# STAFF REPORT SAN CLEMENTE ZONING ADMINISTRATOR

**SUBJECT:** Minor Architectural Permit 20-220 and Minor Conditional Use Permit 21-004, SC Ranch Market Remodel and Outdoor Display Area, a request to consider an outdoor display area, a storage addition, and exterior improvements to an existing 5,300 square-foot commercial building located in the NC1.2 (AH-CZ) Zone.

**LOCATION:** 101 West El Portal

**A. Minor Architectural Permit 20-220, SC Ranch Market Remodel, 101 W. El Portal**  
(Carrillo)

SITE PLAN  
 1/16"=1'-0"

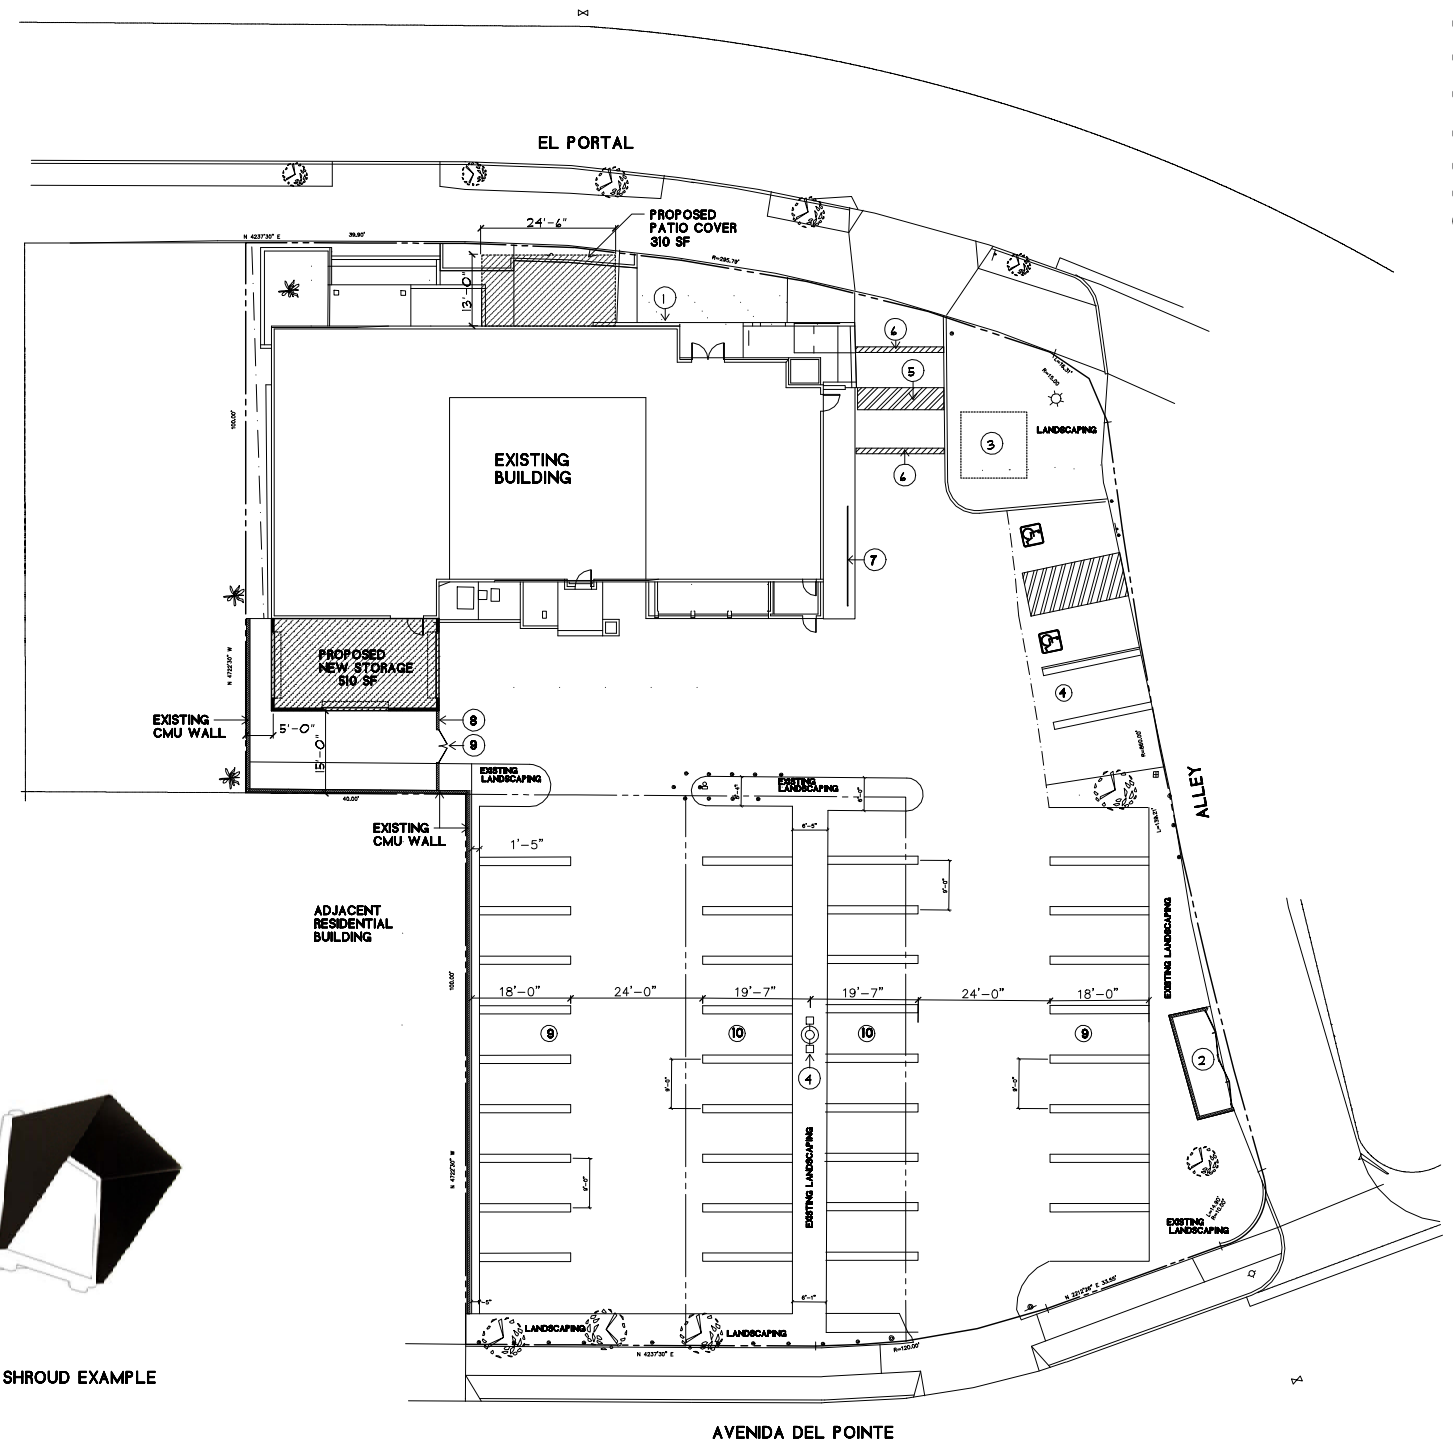
- Supports the remodel of the primary building.
- Expressed concerns with the material and design of the proposed gazebo in the new outdoor display area due to incompatibility with the primary building.
- Suggested reducing the amount of corrugated metal on and around the proposed gazebo.
- Suggested redesigning the gazebo for an open and unenclosed appearance to reduce bulkiness in the subject area.
- Asked the applicant to consider relocating the north point of vehicle egress/ingress for improved connectivity and pedestrian safety between the proposed outdoor display area and the primary building.

- Suggested the applicant use same-sized timbers on the gazebo and attached patio cover for cohesiveness.
- Suggested a site landscape and lighting plan be provided to further improve the entire site.
- Suggested landscaping around the main building be provided to soften bare walls.
- Requested the detached gazebo return for a second review, prior to a public hearing.
- Agreed with staff's recommendations.

The applicant agreed to revise the project design in response to DRSC's comments and suggestions. Further, the applicant agreed to remove the gazebo from the scope of work and submit the proposed detached gazebo under a separate application. Further, the applicant agreed to return to DRSC at a later date to review the unresolved design issues related to the proposed gazebo.

The Subcommittee recommended the project, excluding the gazebo, move forward to the Zoning Administrator for consideration.

**PROPOSED TRASH ENCLOSURE ELEVATION DRAWINGS**

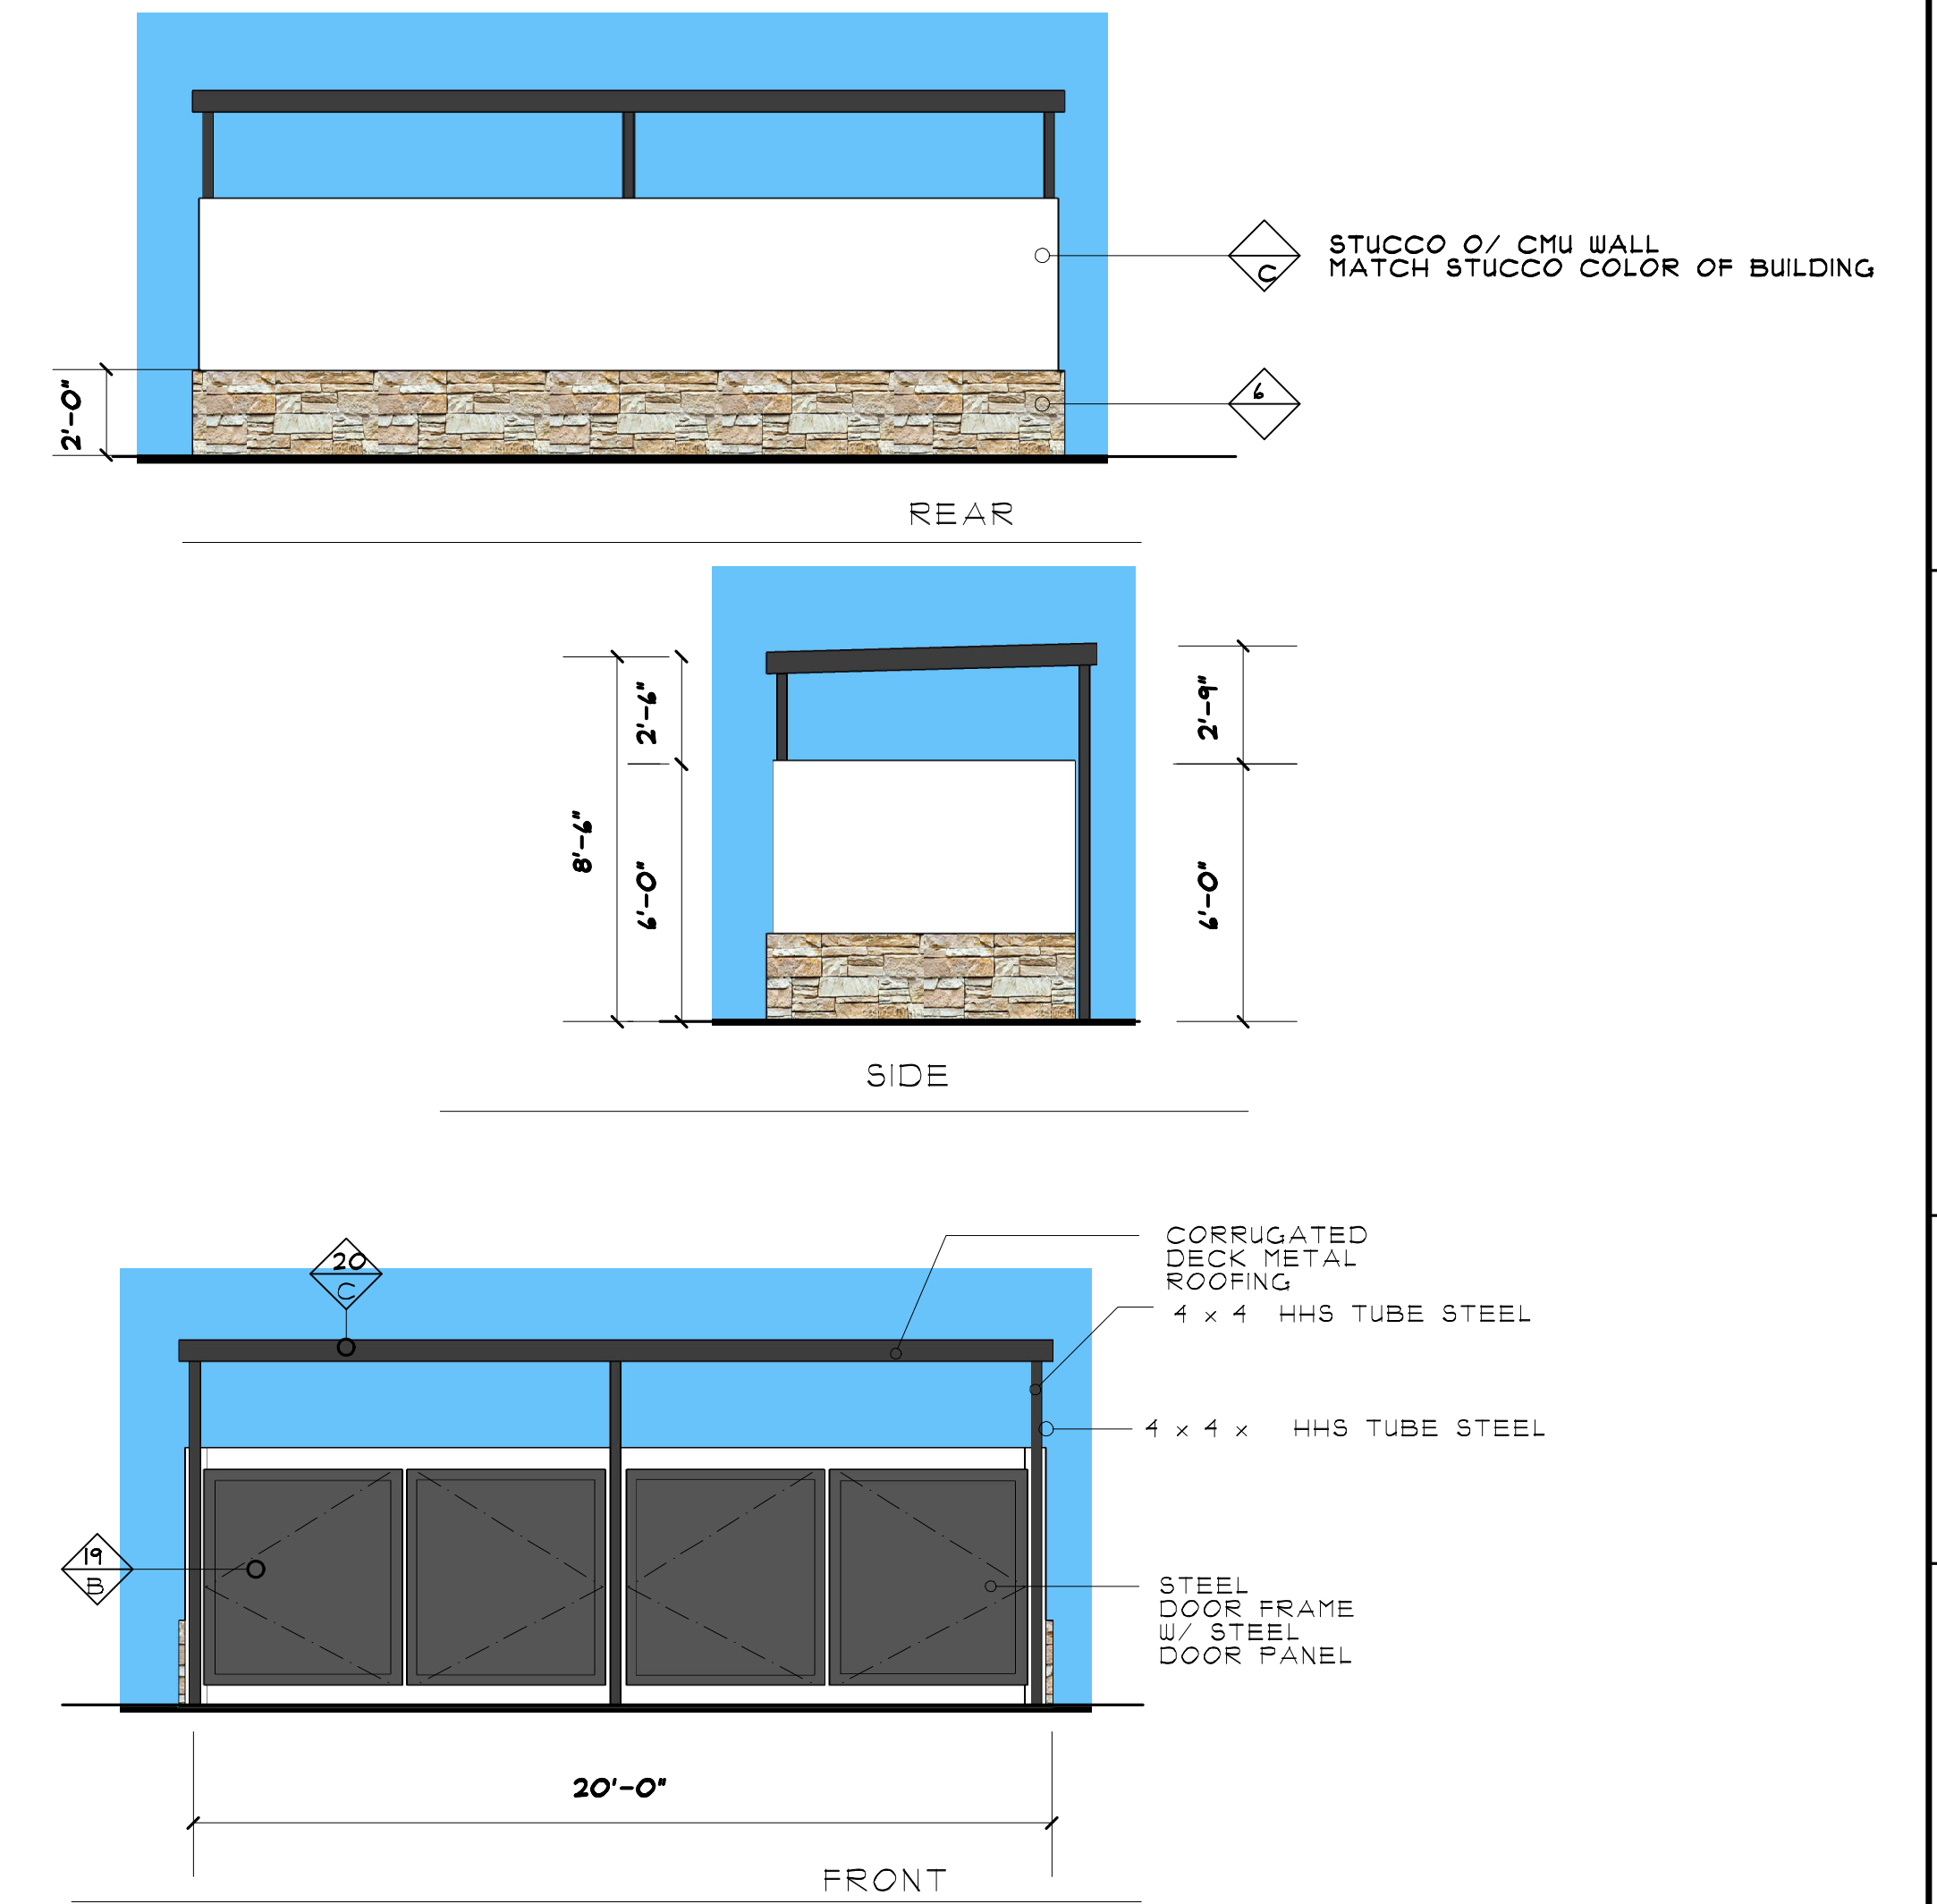
2. Submit a preliminary landscape plan to rehabilitate existing planter areas surrounding the parking lot with drought-tolerant, native landscaping.
3. Remodel the trash enclosure to match the primary building. Improvements to the trash enclosure may include adding stone veneer, painting the enclosure, and/or replacing the gate and cover with compatible materials.
4. Remove unpermitted window advertisements for compliance with Code and increased visibility of the market.
